STATE OF NEW YORK
OFFICE OF GENERAL SERVICES
DESIGN AND CONSTRUCTION GROUP
THE GOVERNOR NELSON A. ROCKEFELLER
EMPIRE STATE PLAZA
ALBANY, NY 12242

ADDENDUM NO. 12 TO PROJECT NO. 44578

CONSTRUCTION WORK - PLA
MAJOR BUILDING RENOVATIONS FOR THE
MANHATTAN FORENSIC
RELOCATION
MANHATTAN PSYCHIATRIC CENTER
600 EAST 125th STREET
WARDS ISLAND, NY 10035

October 20, 2015

A-907B-2

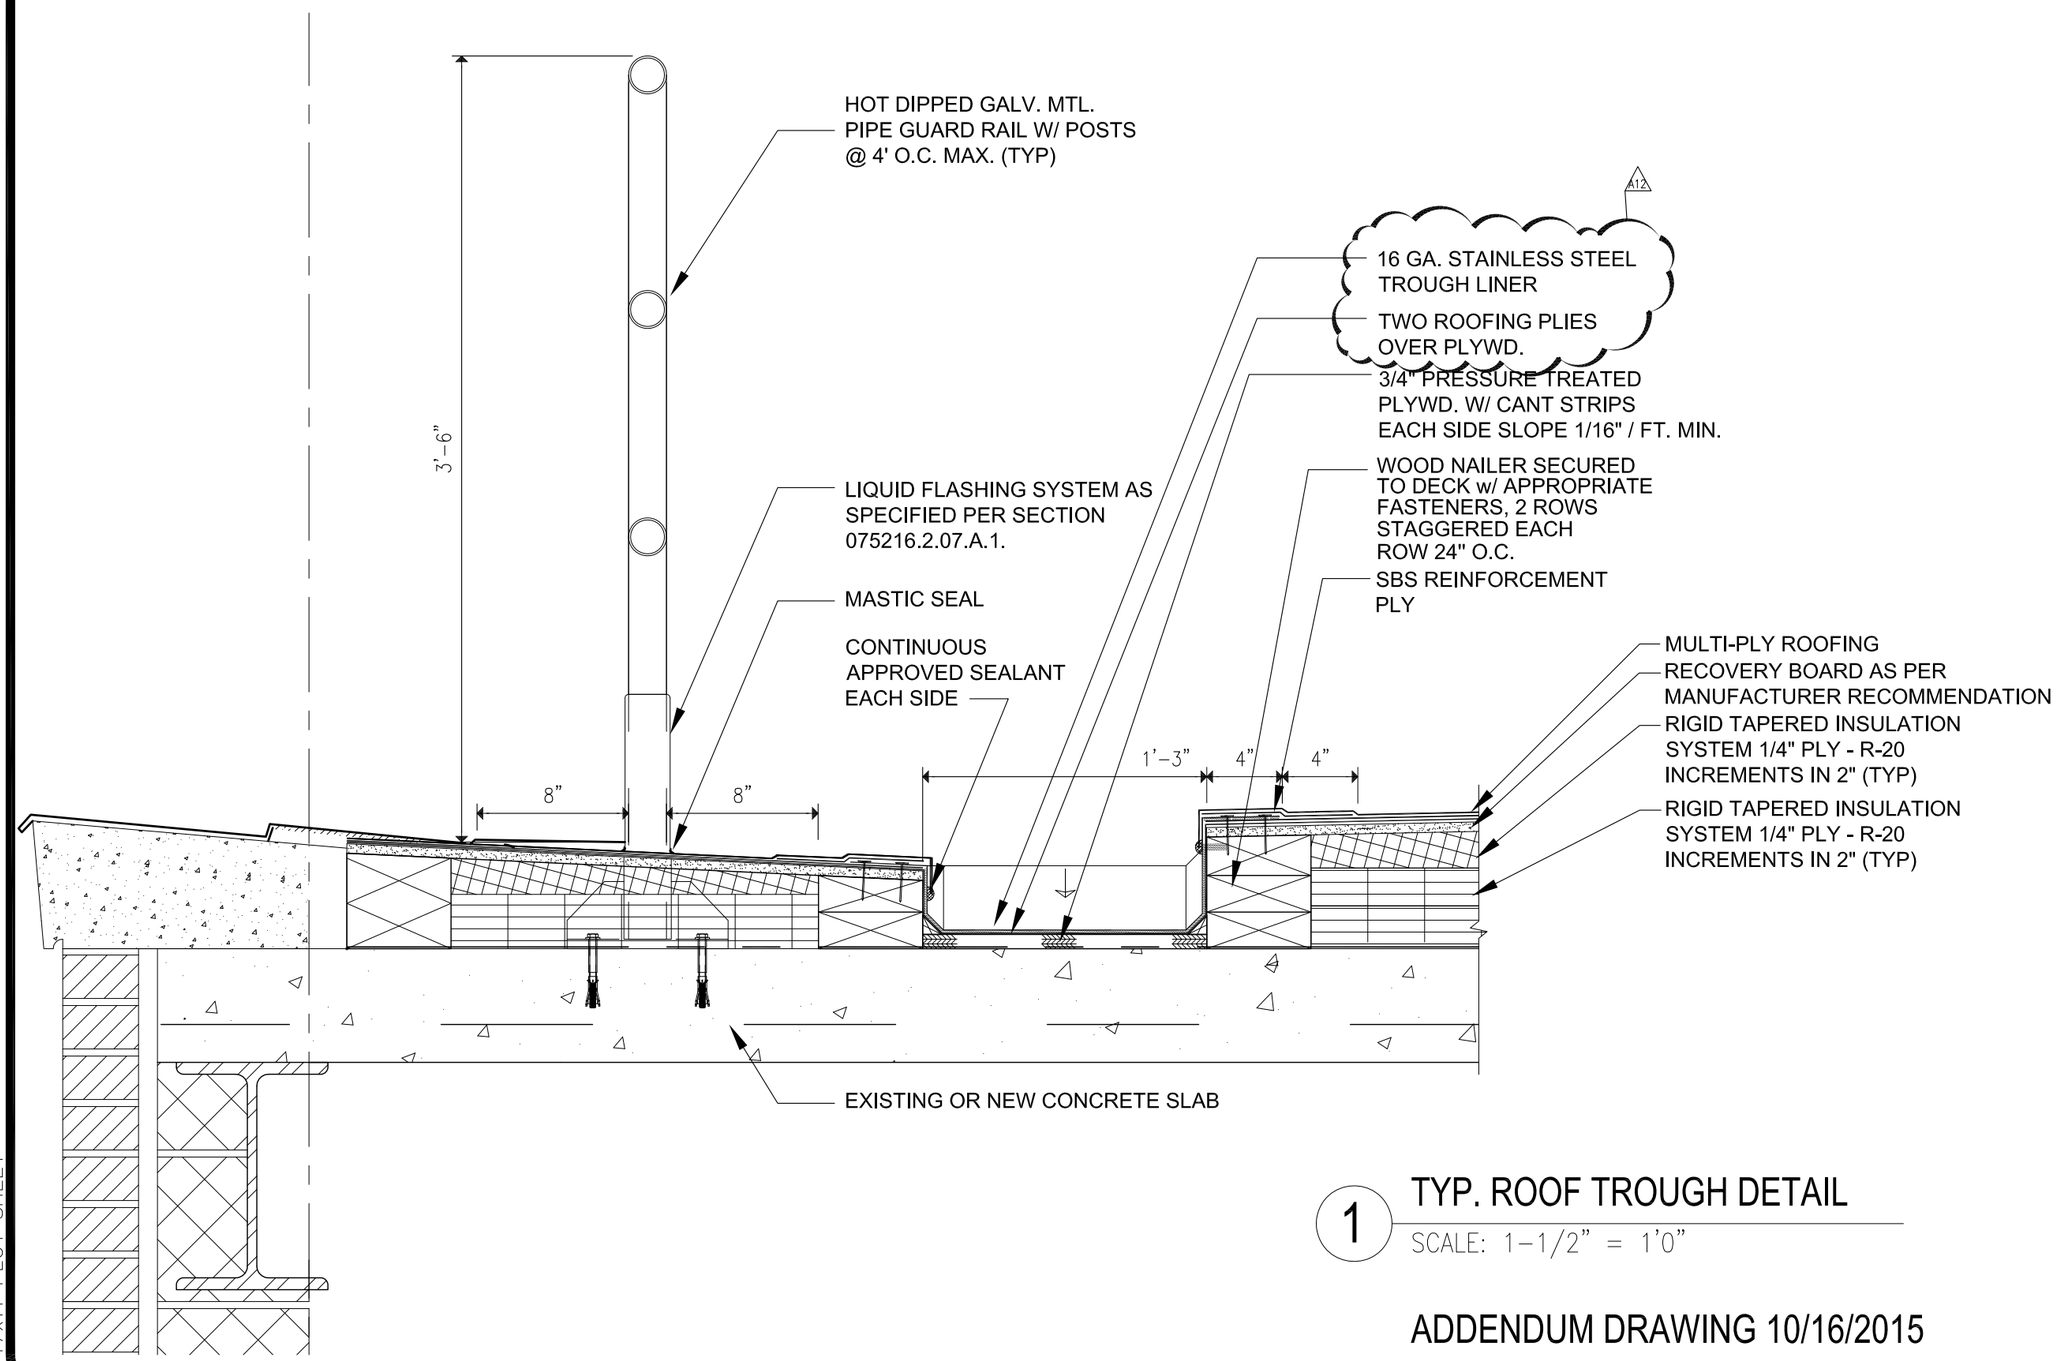
8. Drawing No. A-118-2: Remove all detail references 3/A-907A-2 between col. lines 5.9 and 9 replace it with Addendum drawing A-907B-2.

10. Drawing No. A-907A-2, Detail 1: Delete this Detail in its entirety. Refer to Addendum Drawing No. A-907B-2 dated 10/21/2015 for replacement detail.
